File: endstop-inputs.kicad_sch

Title: Seven-channel endstop inputs

Size: A1	Date: 2026-10-30	Rev: v25
KiCad E.D.A. 9.0.8		Id: 1/1

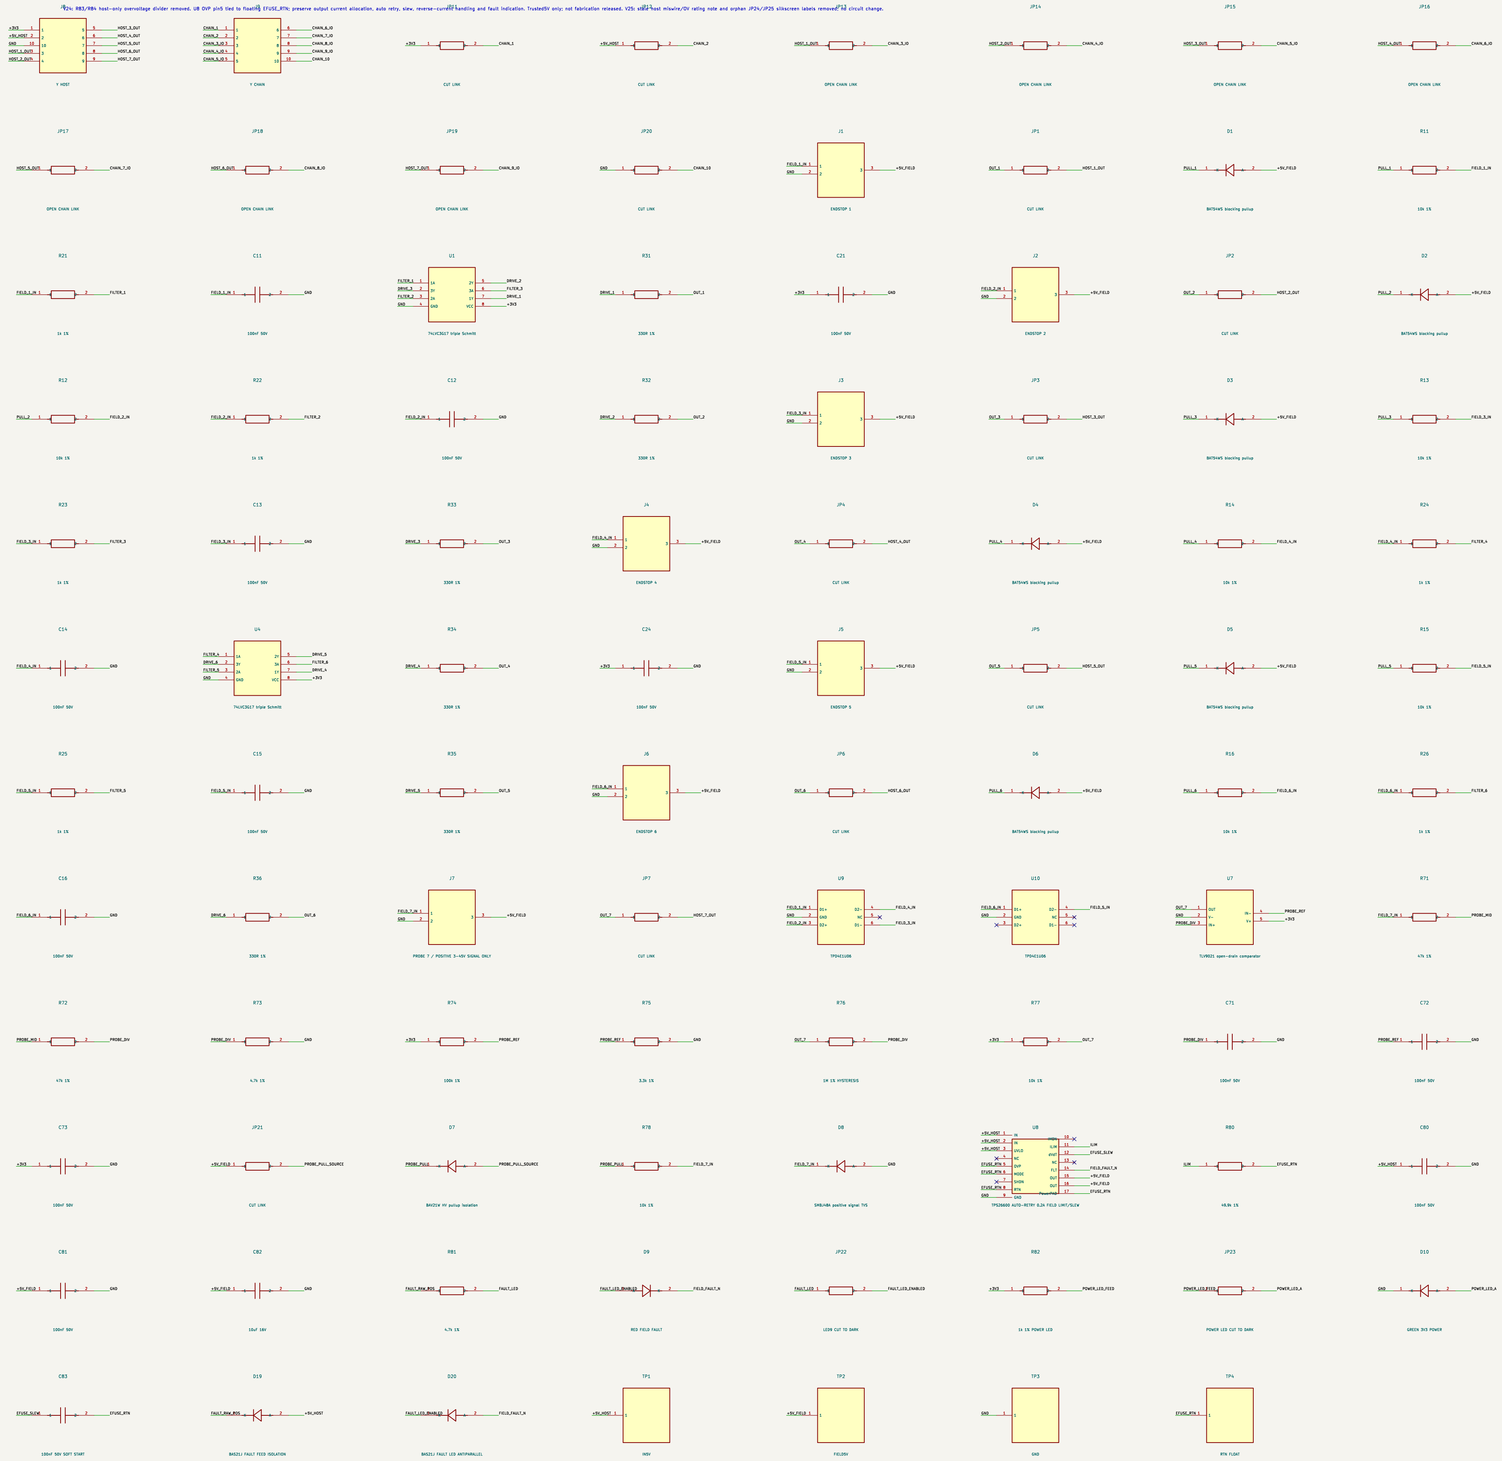
R24: R83/R84 host-only overvoltage divider removed. UB OVP pin5 tied to floating EFUSE_RTN: preserve output current allocation, auto retry, slew, reverse-current handling and fault indication. Trusted5V only; not fabrication released. V25: store host mlswire/OV rating note and orphan JP24/JP25 silkscreen labels removed in circuit change.
